S U B M I S S I O N : B U C K L E
a written submission by way of further objection to DA 2019/1522

Re: 41-43 Beach Road Collaroy NSW 2097
DA 2019/1522

WRITTEN SUBMISSION: LETTER OF OBJECTION
Submission #3: Buckle

This Written Submission is in response to the submission of **Amended Plans** dated 28 May 2020.

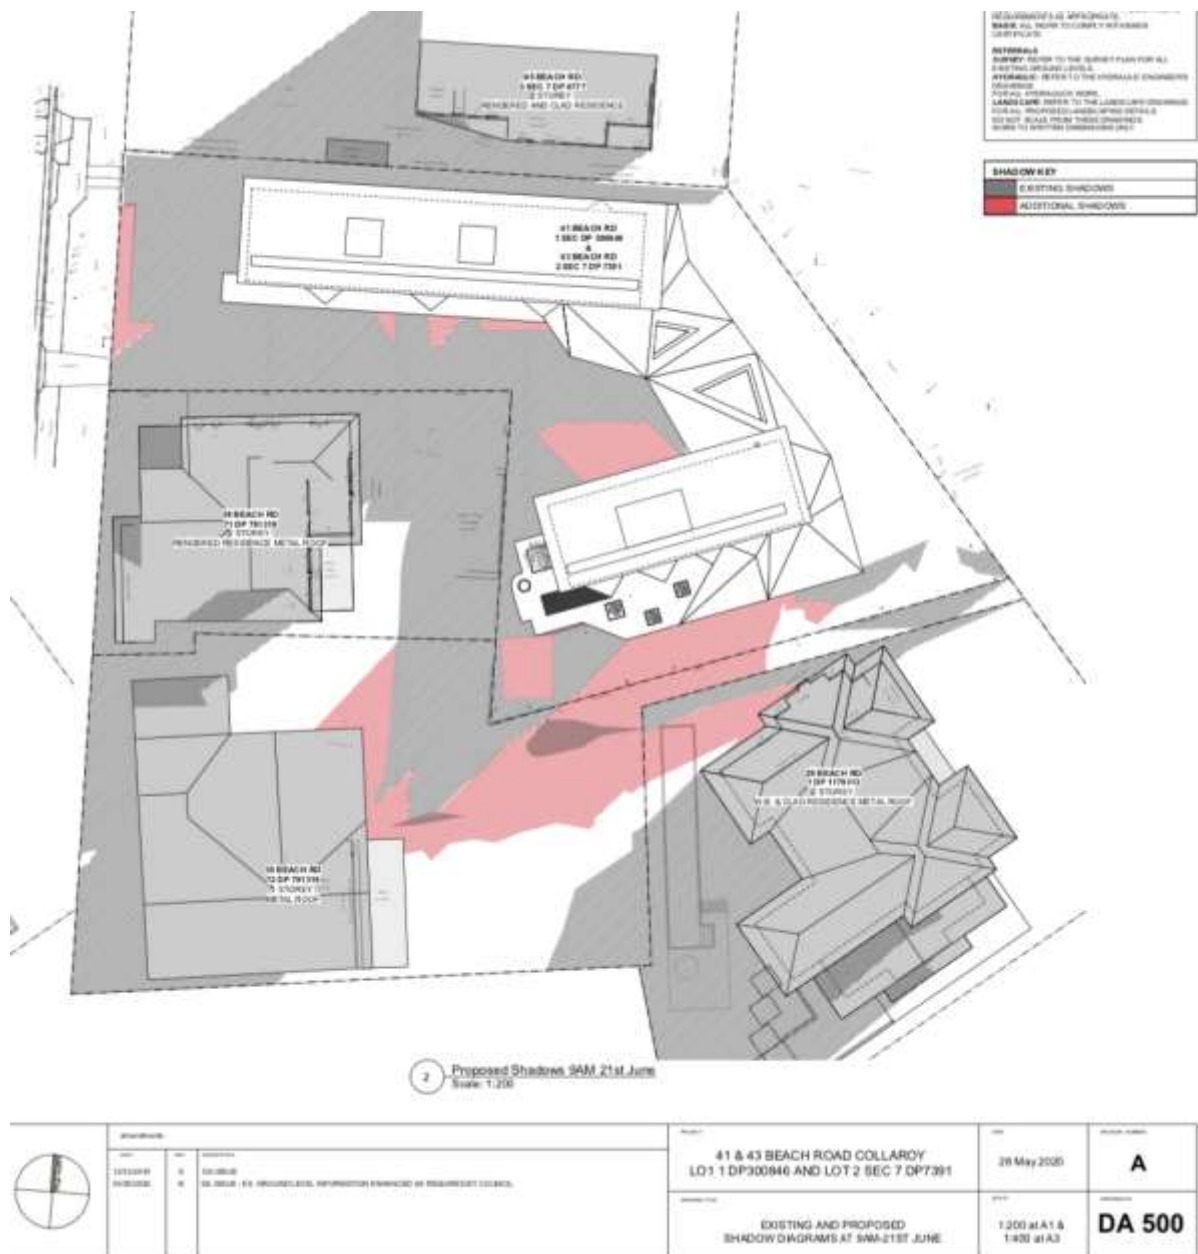
We contend that the DA can avoid the impact by repositioning the southern wing to be maintained within the **DCP B3 Side Boundary Envelope**. A more sensitive design to accord with these controls would achieve the same amenity whilst reducing the impact. The DA has not assessed the difference between a compliant B3 Side Boundary Envelope and the non-compliant envelope in this set of amended plans.

We contend that the DA fails the major objectives and requirements of this control

DA 500 A: Unreasonable overshadowing as a direct result of non-compliant built envelope

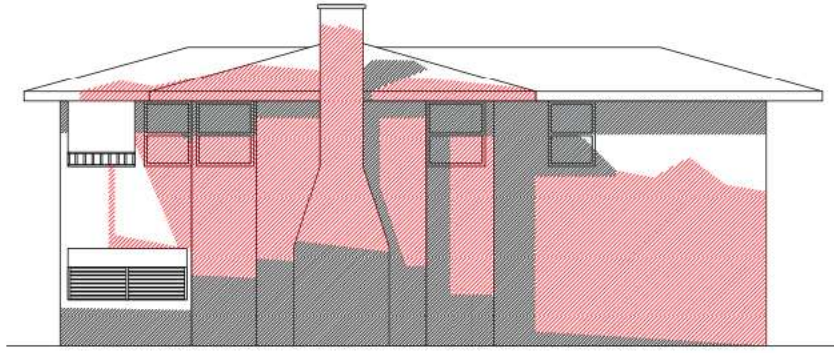
The proposed development does unreasonably overshadow the public open space, by proposing non-compliant development casting additional excessive shadow into the eastern public open space in the afternoons.

02 PROPOSED ELEVATION SHADOWS - 29 BEACH RD. NORTHERN FACADE
12 PM - 21st June

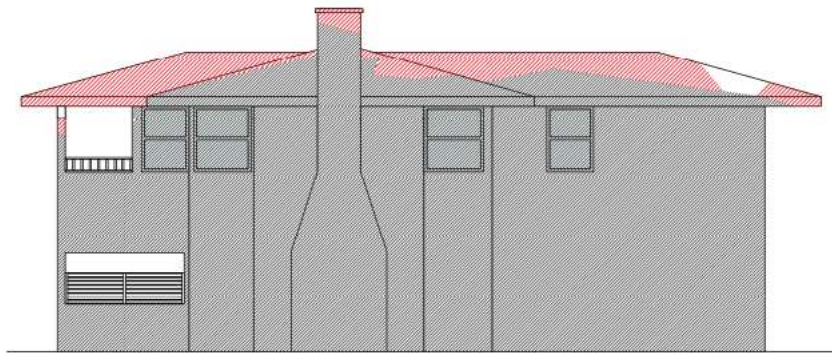
Noon 21 June: The extent of the overshadowing at Noon Winter on our north facing windows and solar panel roof is totally unreasonable, the loss caused by a non-compliant envelope

DA 502 A: The extent of the overshadowing at 3pm Winter on our roof is totally unreasonable, the loss caused by a non-compliant envelope

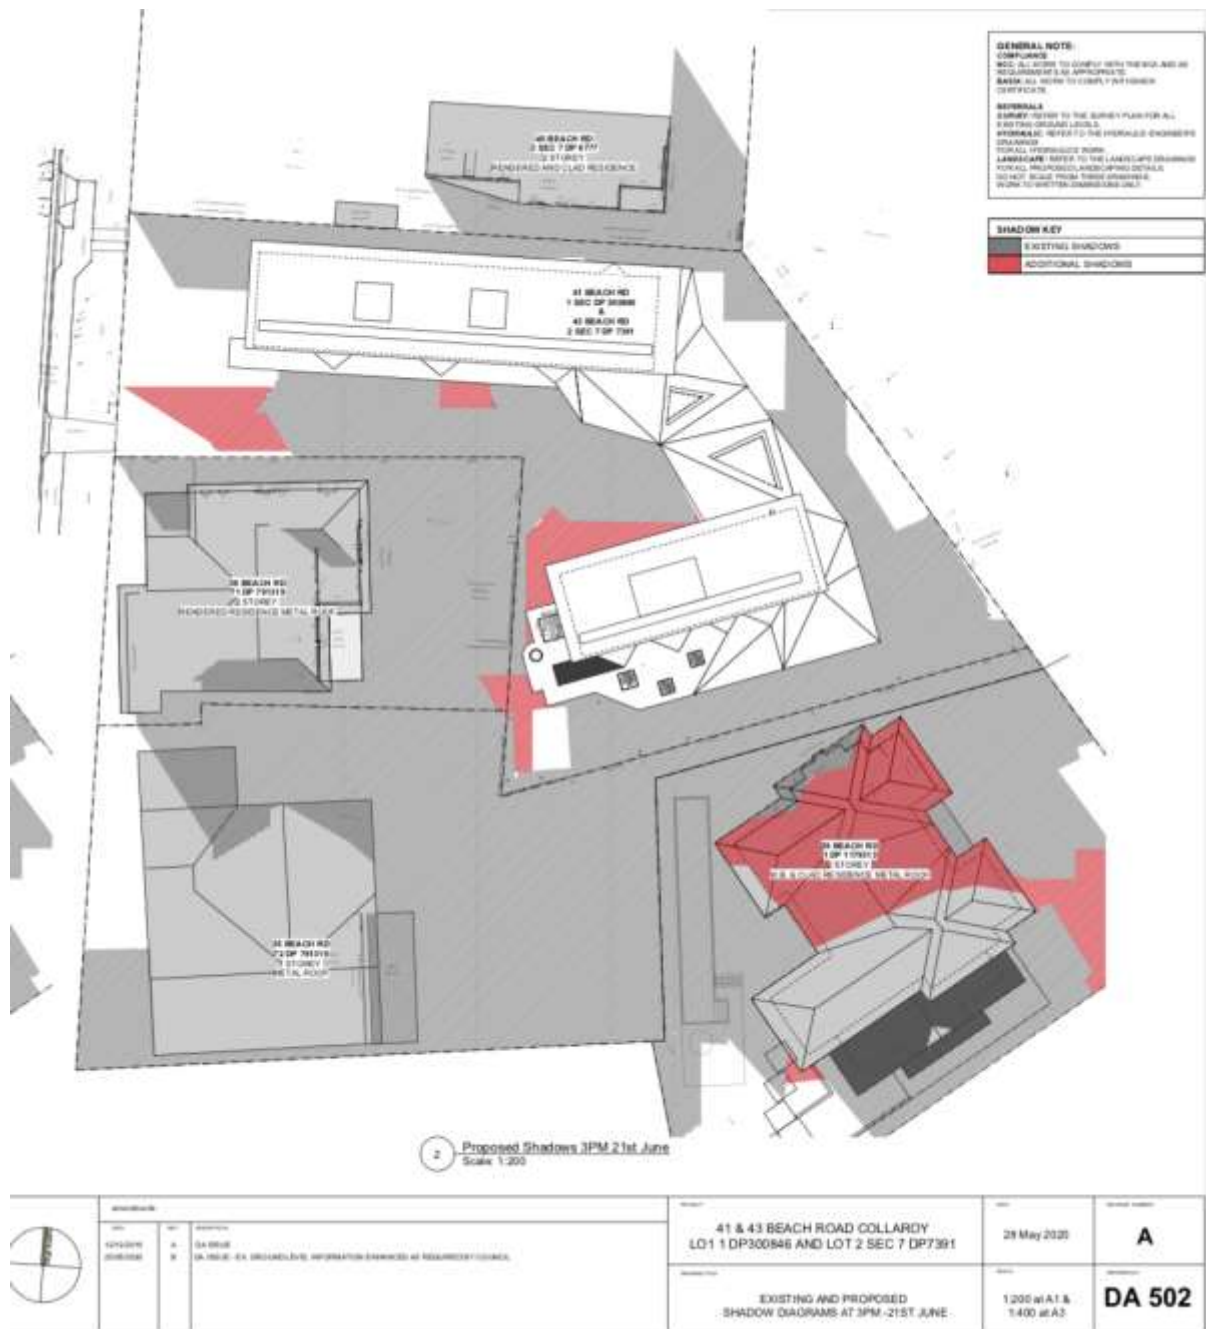
The extent of the overshadowing at 3pm Winter on our roof is totally unreasonable, the loss caused by a non-compliant envelope
